MEMORANDUM

FILE NO.: USE2013 0015

PROPOSAL: Conditional Use permit for a 24-unit apartment complex.

Figure 3: Applicant's design of the proposed apartment building; both buildings will be the same design. The access driveway and parking spaces are in front of each building.

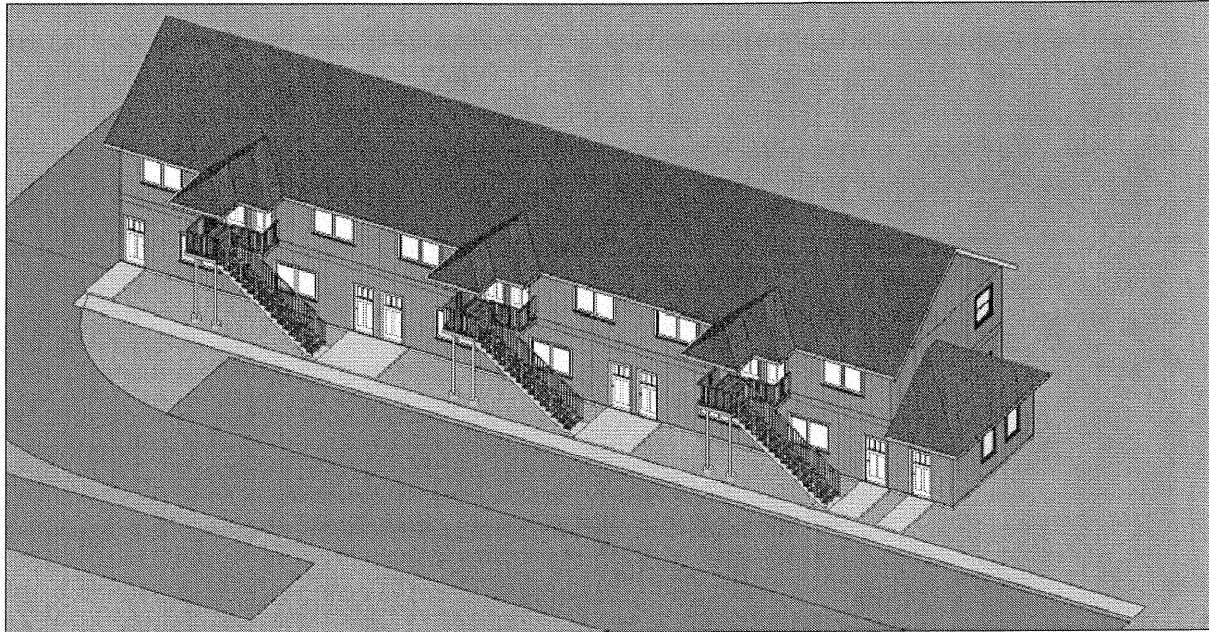
The 24 apartments will be divided into two, two-story buildings each containing 12, one-bedroom units. Enclosed staircases will provide access to the second floor units. Parking will be provided directly in front of each building and across the driveway. These two buildings will be similar in scale to the adjacent Riveredge Park Condominiums.

As stated earlier, the lot contains 2.28 acres. The maximum number of dwelling units allowed on the site is 23 for a D-10 district. Therefore, the application is limited to 23 units unless the lot line is adjusted to incorporate more lot area.

It is recommended that the Planning Commission adopt the Director's analysis and findings and grant the requested Conditional Use permit. The permit would allow the development of a 23-unit multifamily complex. The approval is subject to the following conditions:
